## Response to Anonymous Referee #1

Reply: Done. We have revised this title to “*Development of a plant carbon-nitrogen interface coupling framework in a coupled biophysical-ecosystem-biogeochemical model (SSiB5/Triffid/DayCent-SOM v1.0)*” and eliminated “*Its parameterization, implementation, and evaluation*”.

**Figure R1.** Simulated seasonal variations in GPP, sensible heat, and latent heat against observations at the tundra site.

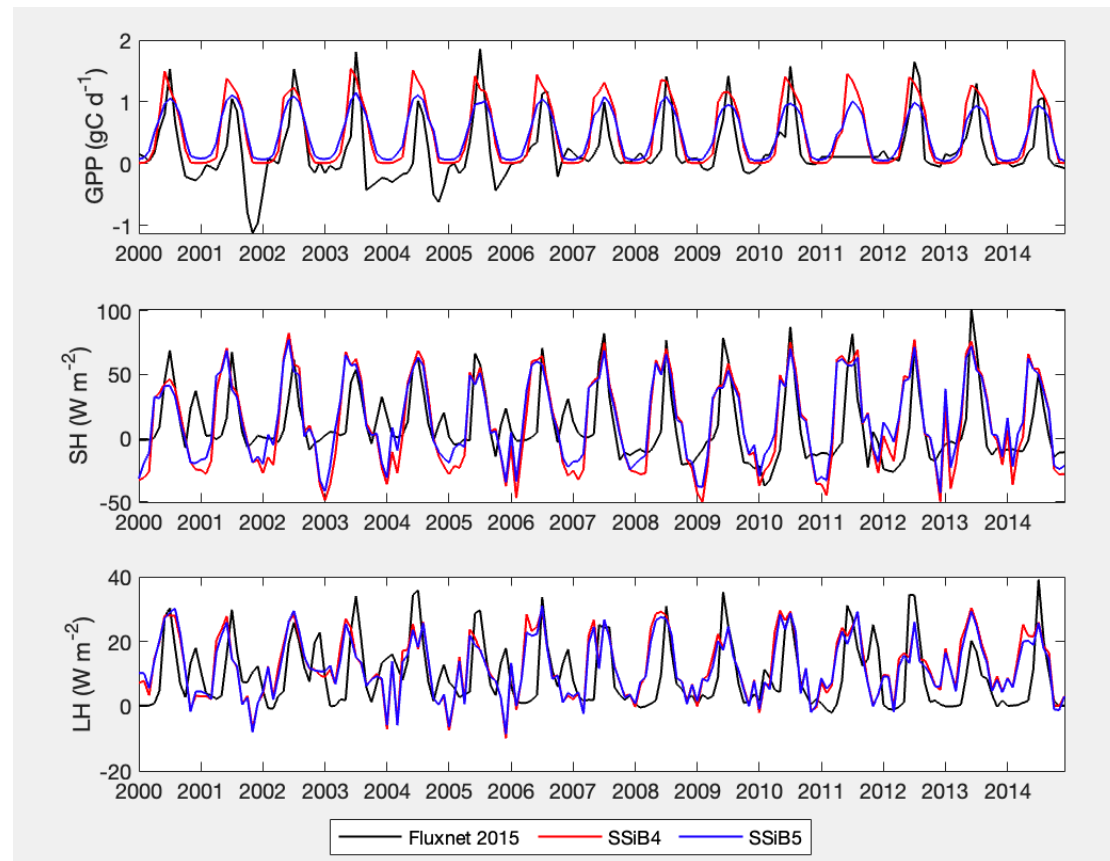
4. Suggest adding some information on tundra shrub as it is not covered in the validation sites (Table 3).

Reply: Thank you for the suggestion. Our validation sites were limited to the AmeriFlux sites. We now include a tundra site (Lund *et al.*, 2012) for validation. The figure attached below is also included in the revised Section 4.1. The results are consistent with those at other sites and are shown in the revised Table 6 (previously Table 5).
